REPLY DOC

RE: Honeywell International Inc.

FCC: CFS8DL5853-3

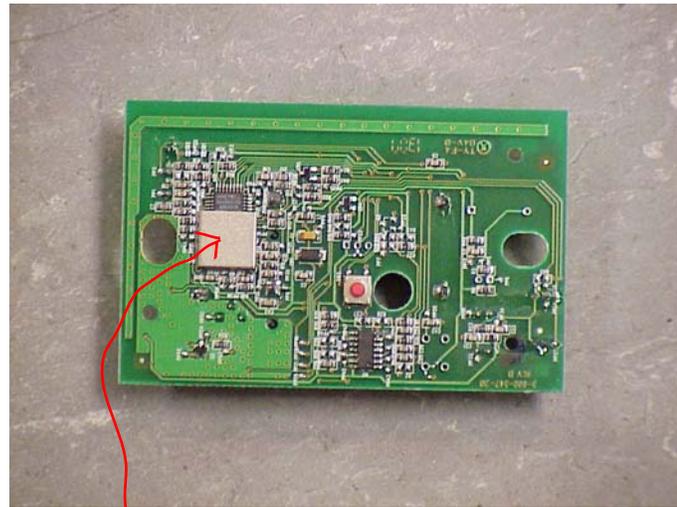
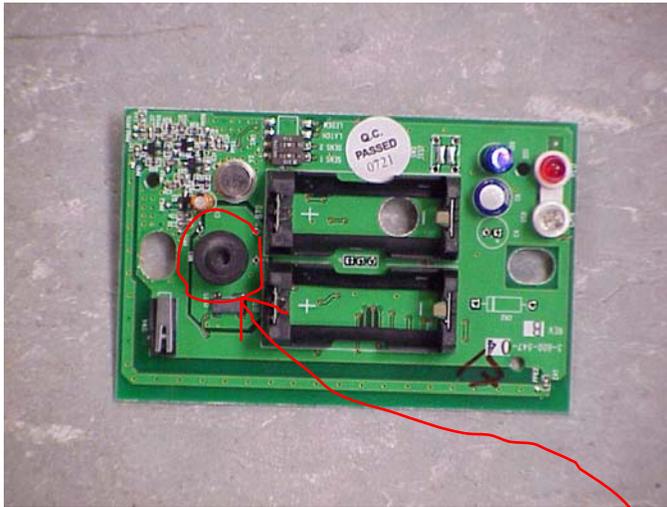
2) The internal photographs should show views with and without any shields/coverings removed. The back appears to contain a shield or covering of some sort. Please provide an additional photograph with this removed. Additionally, the rear photograph should be clearer than provided. Please update.

Tim, FYI: This shield is over the microphone (glass-break sensor inputs) it has nothing to do with the RF portion of the circuit – I will re-photograph rear of PCB.

THE PURPOSE OF THE SHIELD IS TO SHIELD THE MICROPHONE LEADS GOING INTO U1-1 – THE HIGH GAIN AUDIO AMP.
